Department of Transportation

MEMORANDUM

SUBJECT: ZC Case No. 23-08 – Wesley Theological Seminary Planned Unit Development
ZC Case No. 23-08(1) – Wesley Theological Seminary Campus Plan 2022-2032

SUMMARY OF DDOT REVIEW

Figure 5 | Existing Pedestrian Facilities

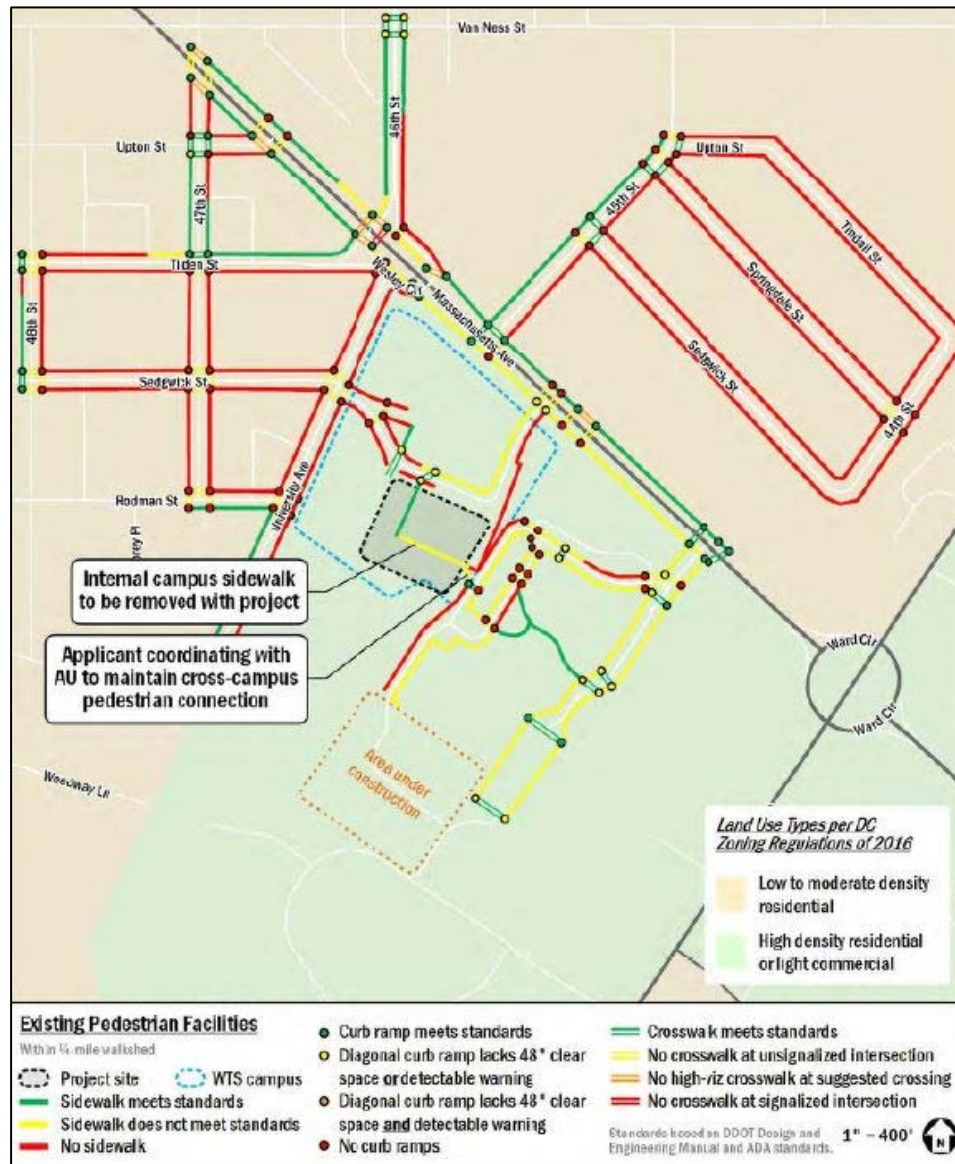
The Applicant's inventory of the pedestrian infrastructure in the vicinity of the campus, as shown in Figure 5 shows that there are significant missing connections in the study area, particularly along University Avenue. To help offset the projected increase in traffic volumes and to encourage non-automotive travel to and from Campus, DDOT requests the Applicant commit in the TDM Plan and PMP which includes installing the missing sidewalk along University Avenue, the missing ADA facilities with a lead walk into campus, and wayfinding signage on-site for residents seeking to walk to American University campus.

Figure 6 | Existing, Planned, and Proposed Bicycle Facilities

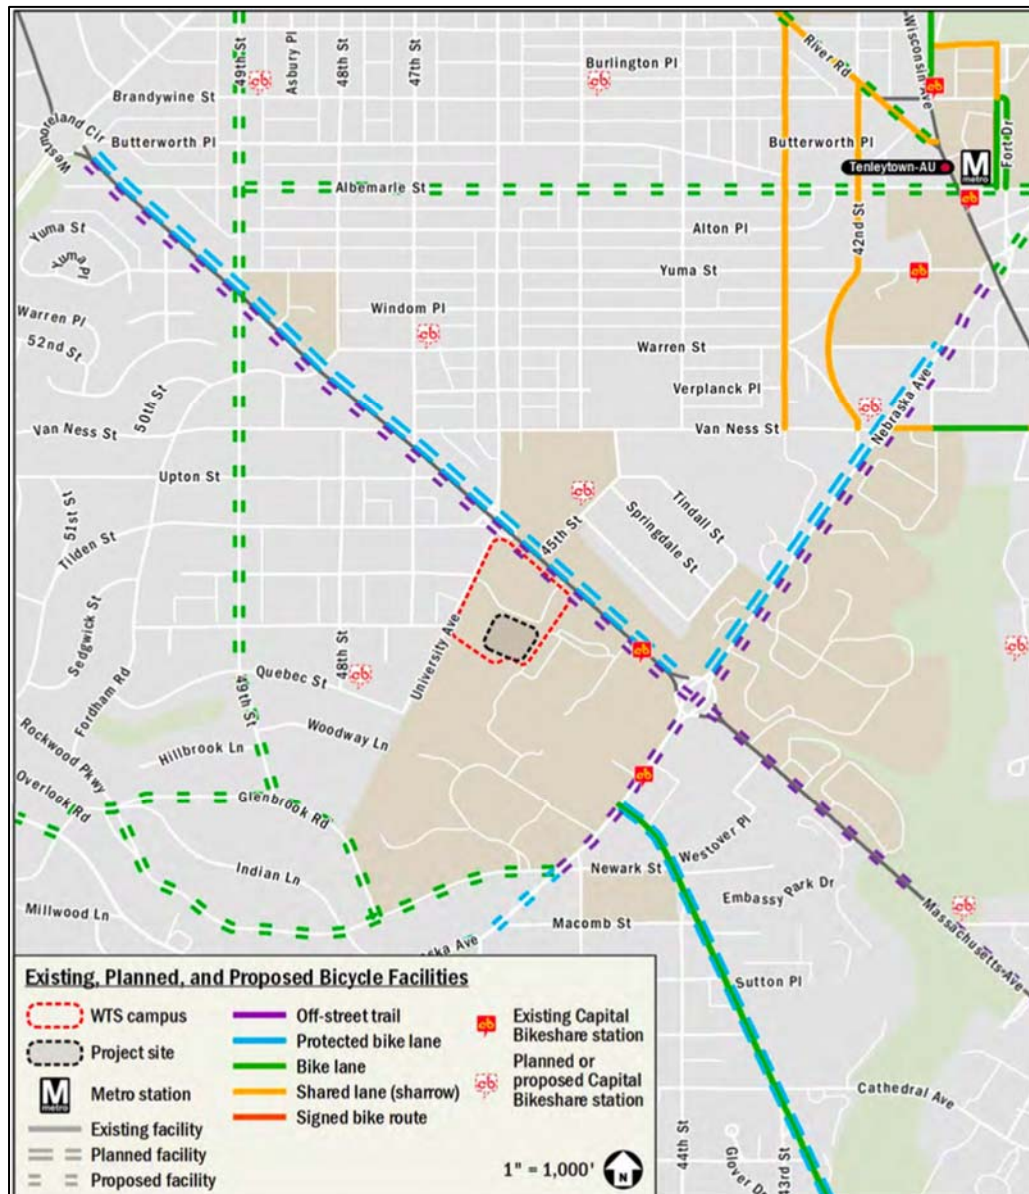
The Applicant will be upgrading all on-campus short-term bicycle parking to U-racks and installing an additional 12 bicycle racks due to increased demand. As shown on Figure 6 below, there are currently not many existing bicycle lanes or trails within 1/2 mile of the site, however there are several planned facilities in the future.
